Technical Service Bulletin: TSB110040

New Composite Air Compressor Cover

Figure 1. Existing Aluminum Compressor Cover with 12 Point Capscrews

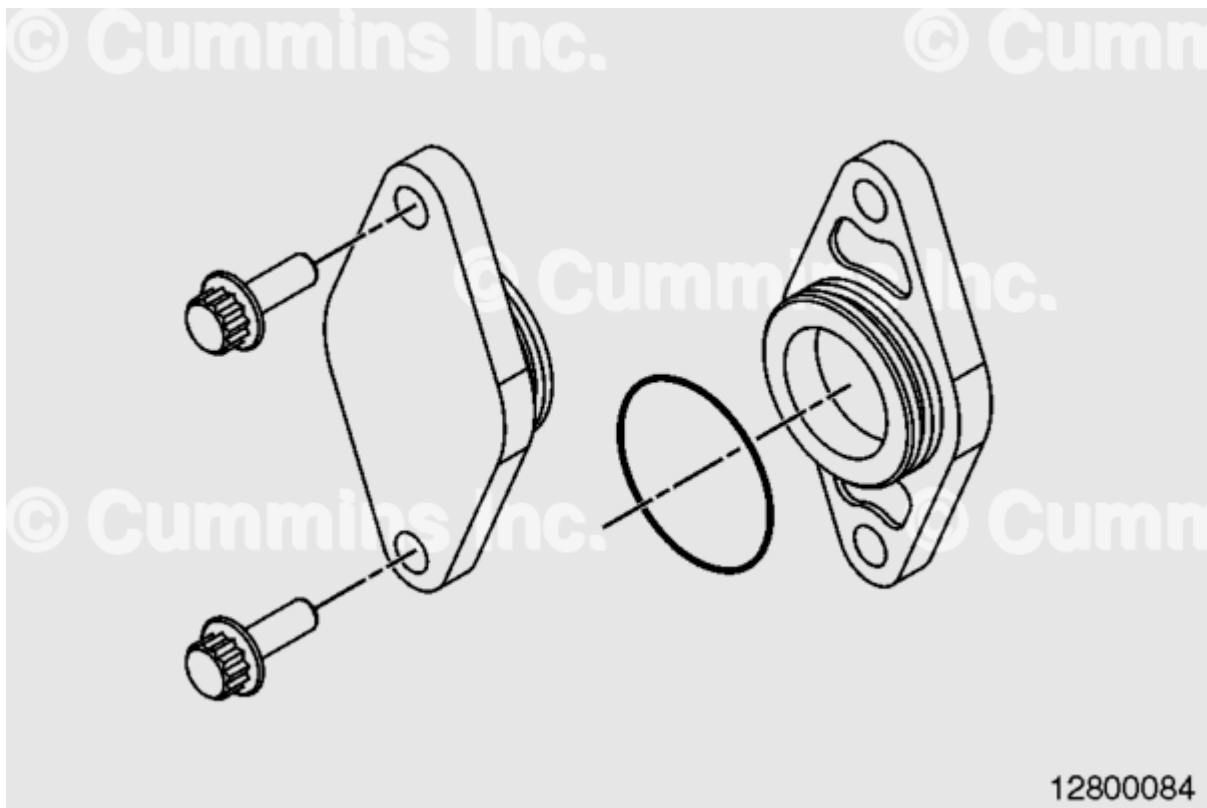
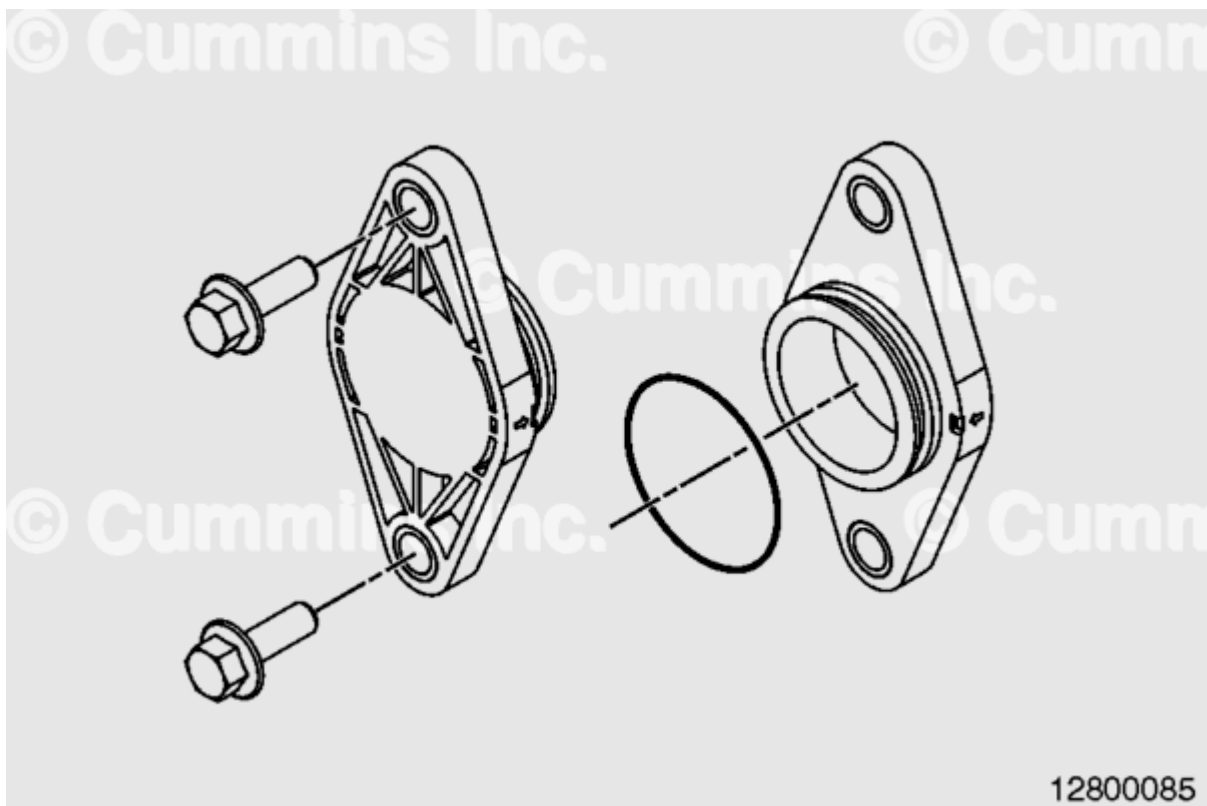
The purpose of this document is to announce the release of a new composite air compressor cover applicable to air compressor options CP 9517, CP 9571, CP 9703, HD 9380, HD 9217, and HD 9711. The new cover replaces the existing aluminum cover and requires different retaining fasteners. The existing aluminum cover and 12 point capscrews have been superseded with the new composite cover and flange head capscrews. The fasteners required for each cover type can **not** be interchanged. The same radial seal is used with both types of cover. The table below contains the required part numbers for each cover type. Figures 1 and 2 illustrate the details of the changes.
